DEPARTMENT OF PARKS AND COMMUNITY SERVICES

October 13, 2023

Subject: Bull Hill and Rolling Meadows Sketch Plan (SKP233)

Bull Hill and Rolling Meadows Sketch Plan Review

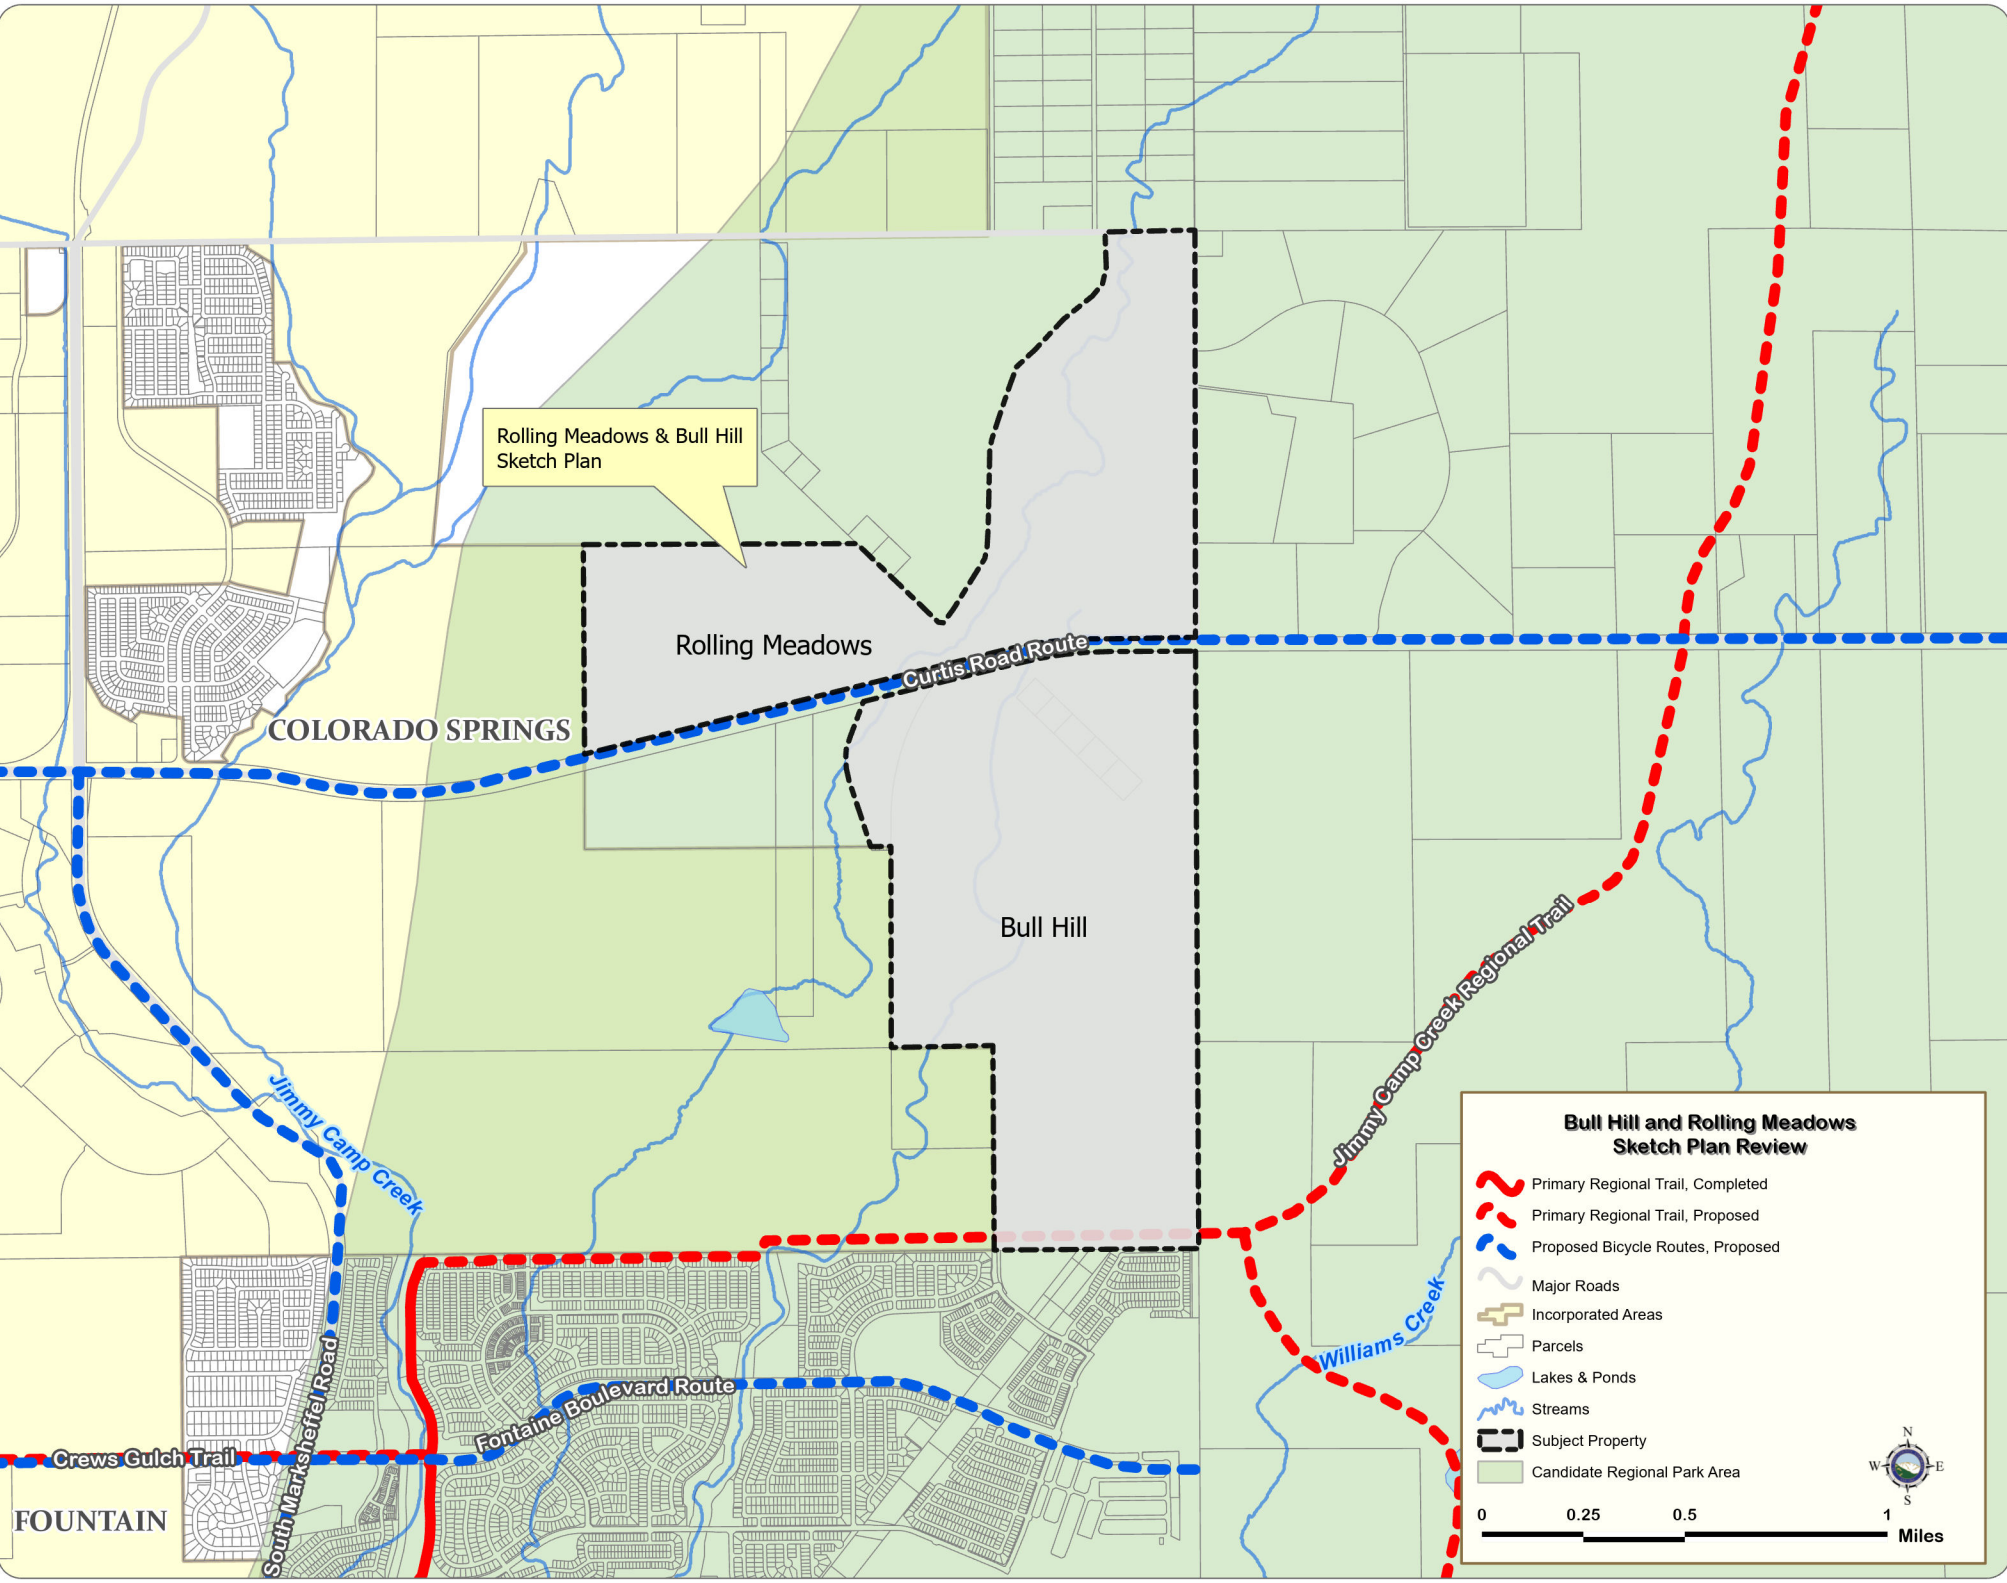
The El Paso County Parks Master Plan shows regional trails within the vicinity of the project. The proposed Curtis Road Bicycle Route follows Bradley Road east and west through the middle of the site. The proposed bicycle route will be accommodated within the public right-of-way in the future, so no easement requests are necessary at that location. However, the proposed Jimmy Camp Creek Regional Trail would be impacted by this project. The proposed Jimmy Camp Creek Regional Trail will run east and west along the south side of the Bull Hill project site. This proposed trail is a tier I primary regional trail that connects to a completed section of the trail in the Lorson Ranch subdivision. Long-term, this trail will connect the city of Fountain to neighborhoods east of Colorado Springs and Corral Bluffs Open Space.

The letter of intent mentions that the powerline easement is a potential trail corridor which may provide trail connections to adjoining neighborhoods. However, there are no trail corridors shown on the sketch plan drawings. Consistent with the Land Development Code (LDC) guidelines for sketch plan applications, staff requests that the applicant show all public trails, including County and non-county trails and bicycle routes on the sketch plan drawings. It would also be helpful to better understand how trail connectivity will be provided across major roadways such as Bradley Road and to adjoining subdivisions such as Lorson Ranch.

County Parks requests trail easements where development projects impact proposed County trails. As it pertains to this application, there are no dedications required at this time. County Parks will be making easement requests on subsequent applications to provide a 25-foot public trail easement along the south side of the Bull Hill subdivision that allows for public access, as well as construction and maintenance by El Paso County of the Jimmy Camp Creek Primary Regional Trail.

Bull Hill and Rolling Meadows Sketch Plan Review

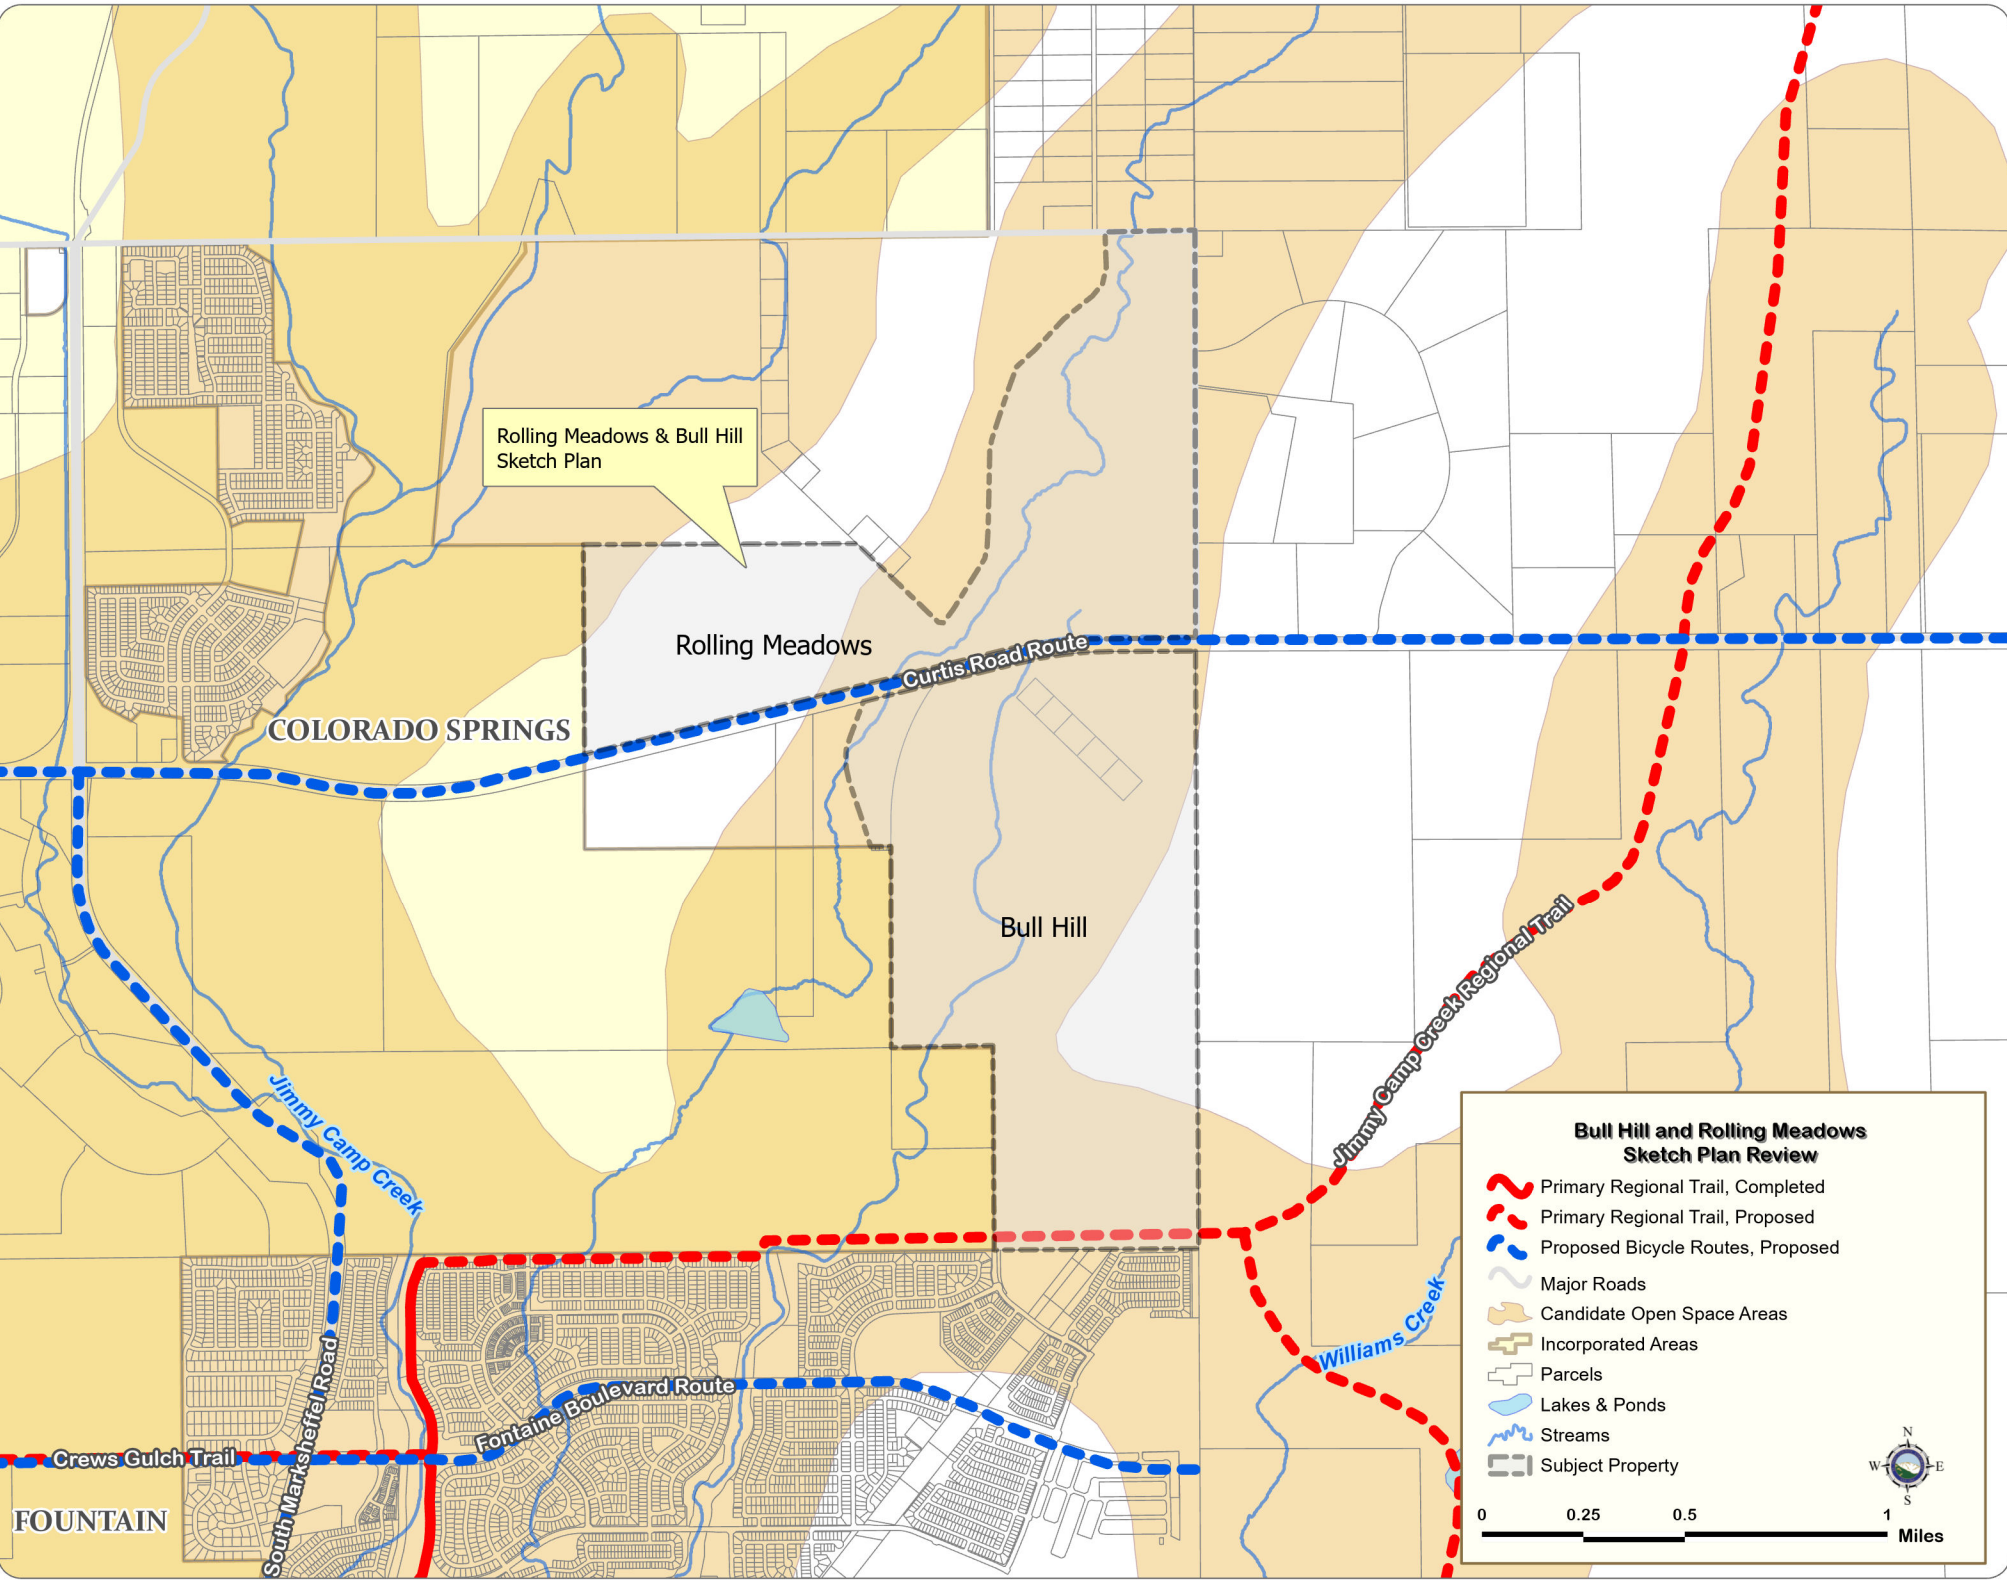
The sketch plan area lies within a Candidate Regional Park area of the El Paso County Parks Master Plan. The area was developed by overlapping areas of high conservation values with high growth parts of the county that are underserved by regional parks. A mix of outdoor recreation opportunities is needed in this are of the County. The nearest regional park to the proposed sketch plan area would be Fountain Creek Regional Park, which is seven miles to the southeast.
